Genesis Solar Energy Project - Docket Number 09-AFC-8

Minor Changes to the Genesis Solar Energy Project Description

**6-pole Extension of Transmission Line
Inclusion of Distribution and Telecommunications Line
Removal of “Toe” Area from Plant Facility**

Submitted by Genesis Solar, LLC
Dated May 21, 2010

Figure 1

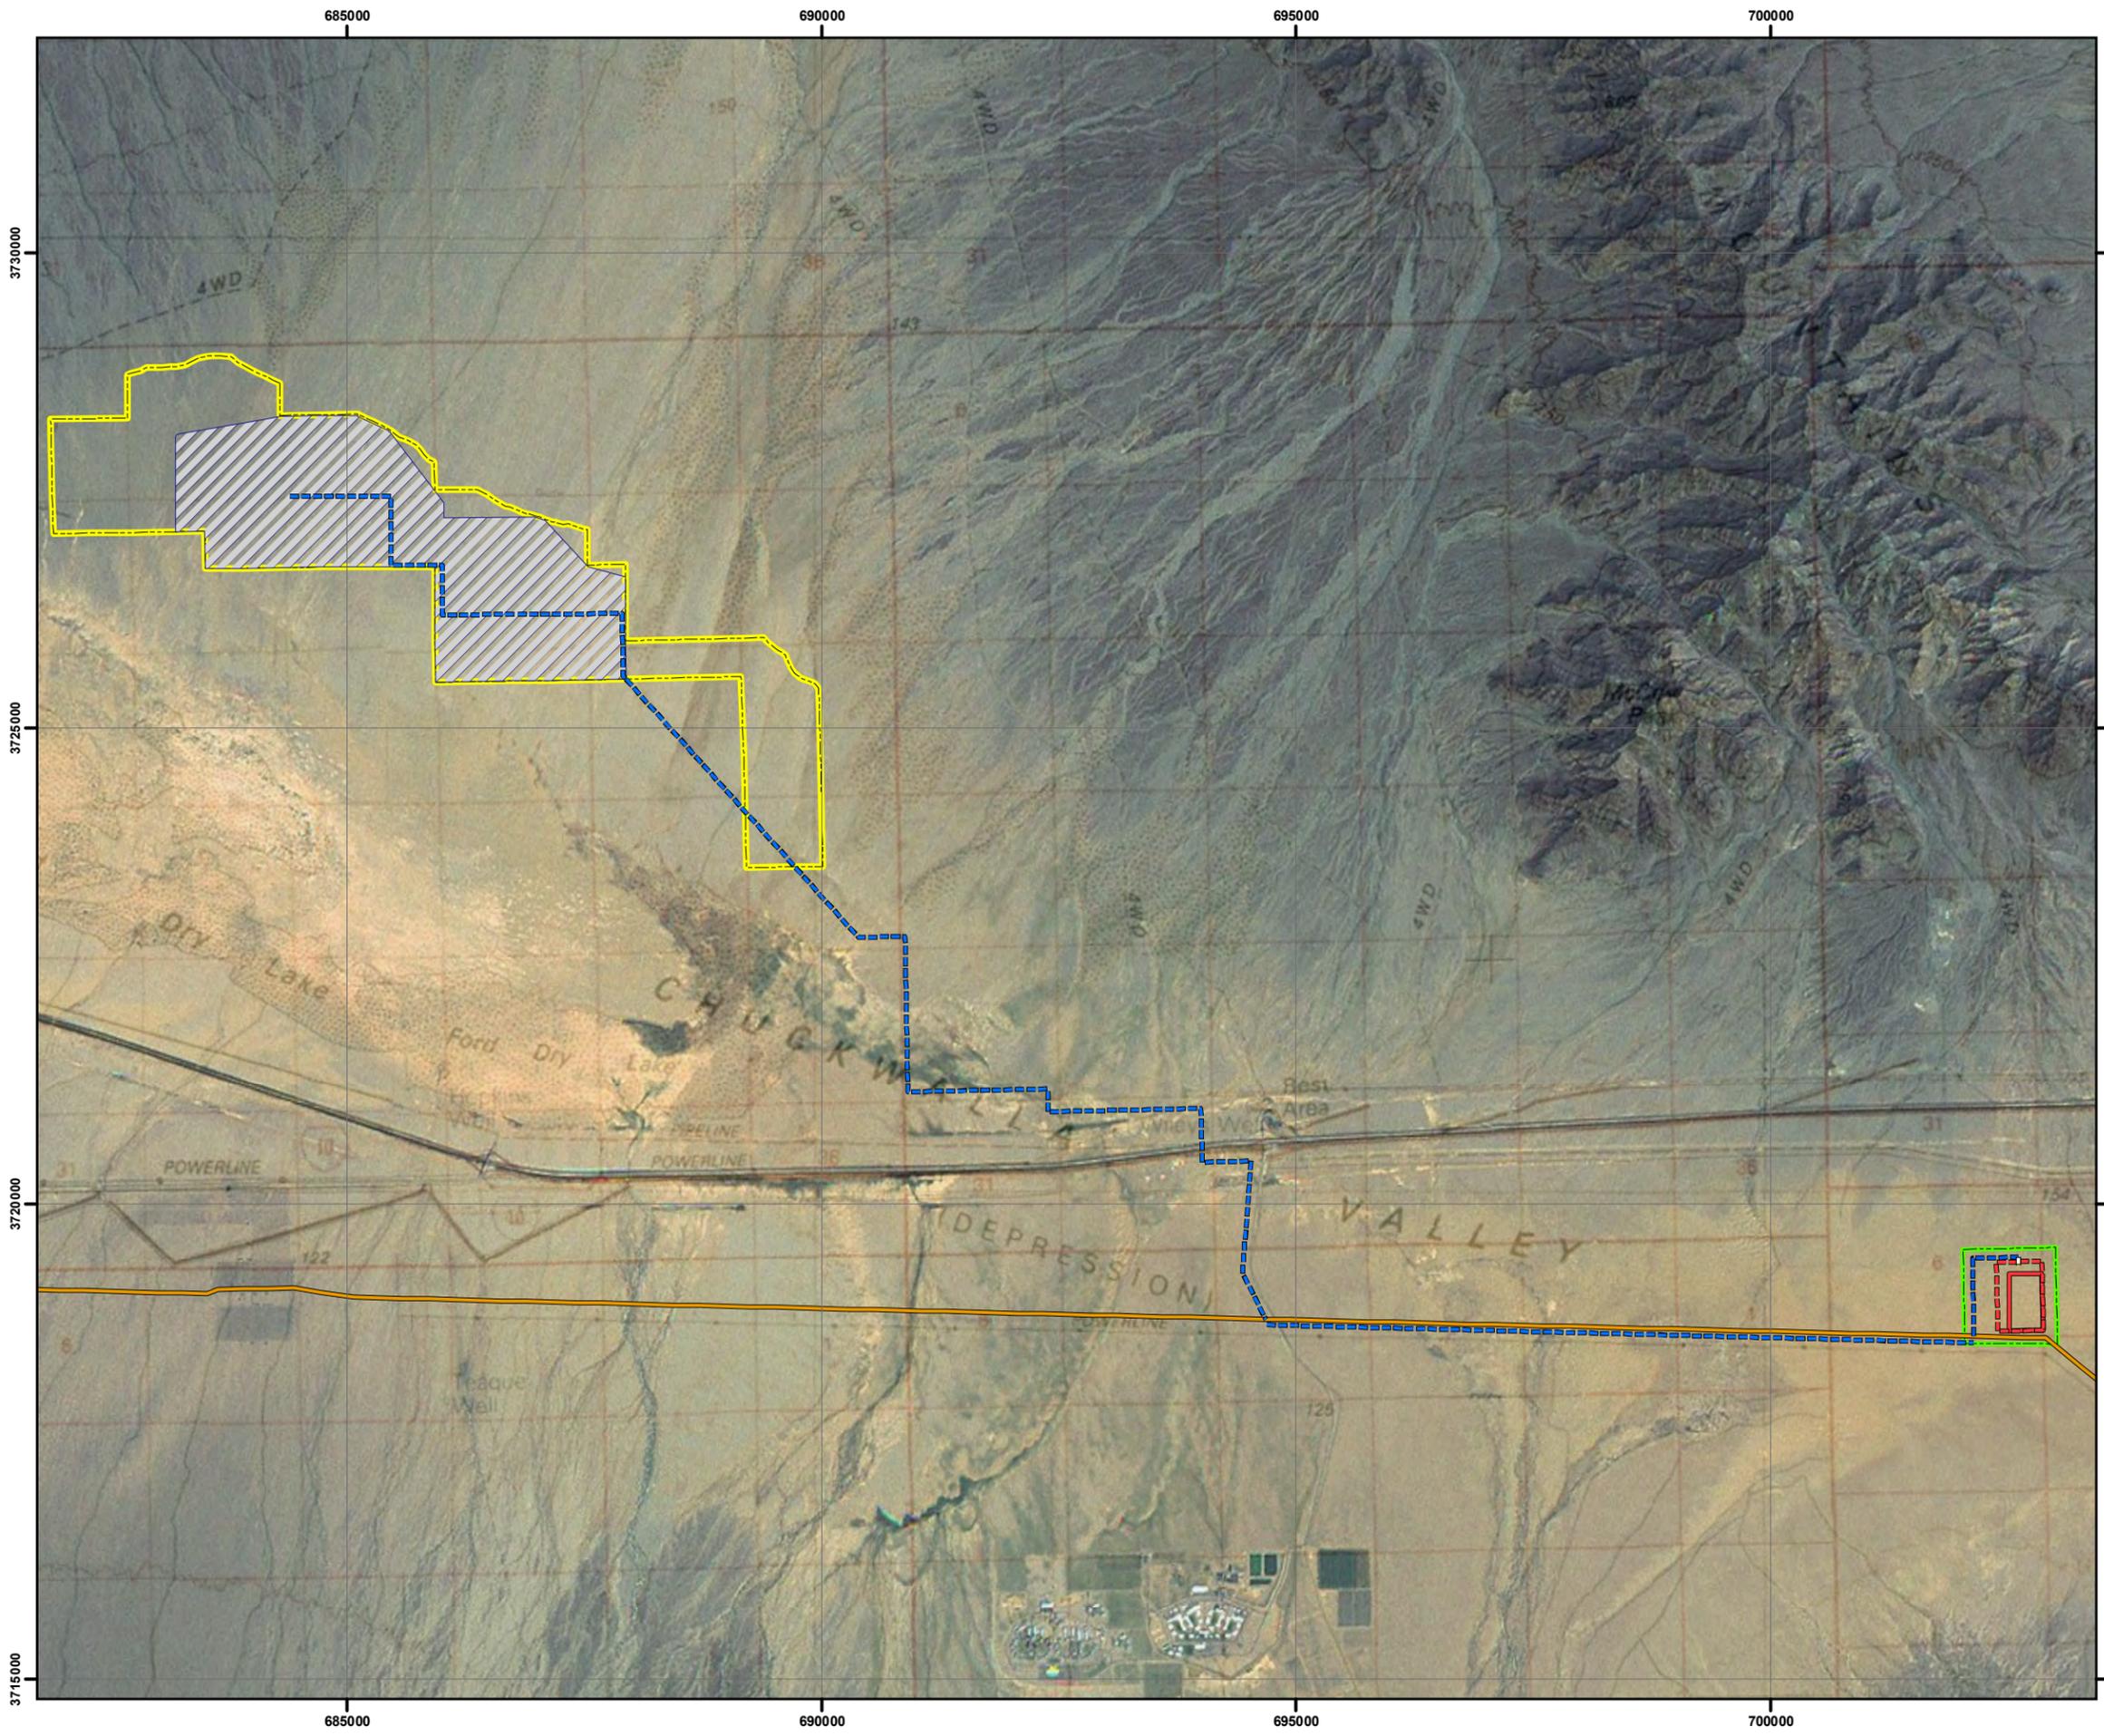
In Figure 1 (attached), the Genesis gen-tie is presented in one color (blue) and the CRS facilities are presented in another color (red) to visually depict where the Genesis gen-tie ends and where SCE's CRS begins. As described in the CEC Application for Certification (AFC) and subsequent documents, the Genesis gen-tie would start at the Genesis power plant site and go approximately 7 miles to southeast until it reaches the existing Blythe Energy Transmission Line Project (BETP). From that point, the Genesis gen-tie would be strung eastward along existing BETP poles until the point where it leaves the BETP to enter into the CRS. Because the BETP runs immediately to the south of the proposed CRS location, Genesis had always assumed the gen-tie would go directly from the BETP poles into the south side of the CRS in a single span. However, SCE recently provided Genesis with a substation design that now requires the gen-tie, after it leaves the existing BETP poles, to come up around the western side of the substation and enter from the north (see Figure 2 attached). As shown in

Figure 2

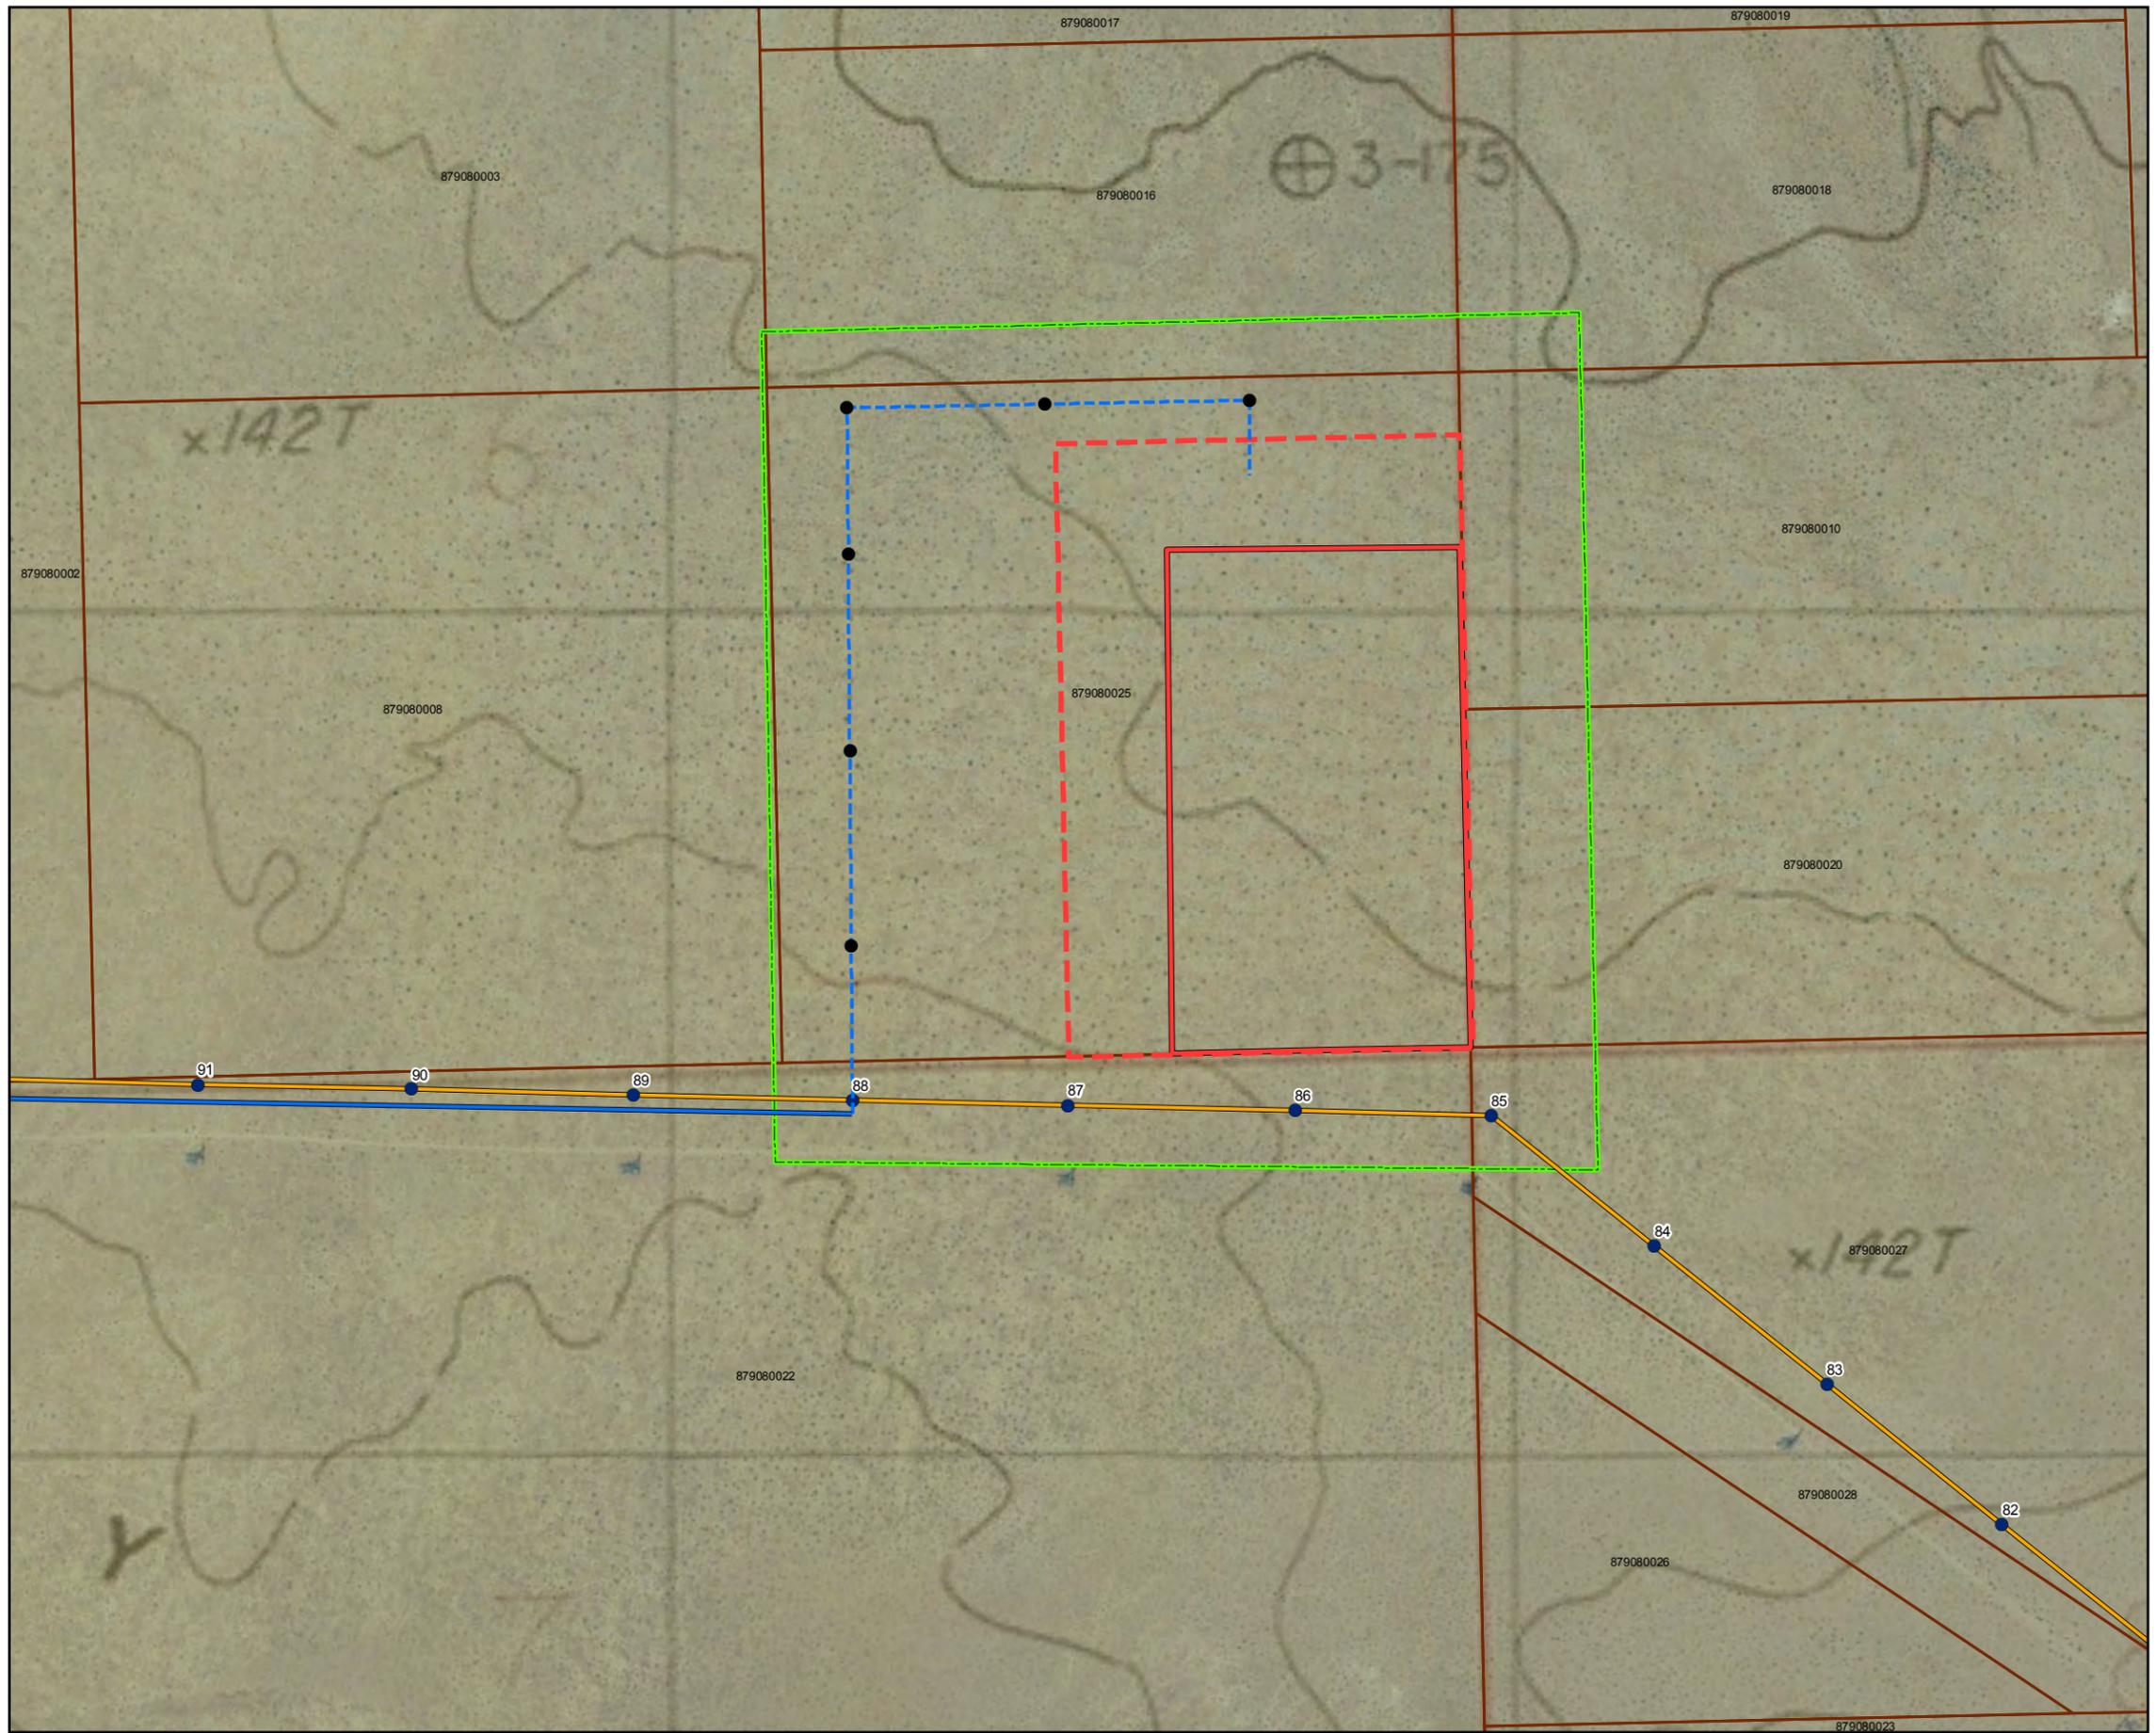
Figure 2, this will require Genesis to add up to six additional gen-tie poles before entering the CRS.

Biological and cultural resource surveys of the area that could be potentially impacted by the six-pole extension of the gen-tie line were conducted in the spring of 2010 in conjunction with surveys that were being conducted for the CRS. Figure 2 shows the boundary of the biological resources survey area. The additional acreage is characterized as flat and exhibits general desert conditions.
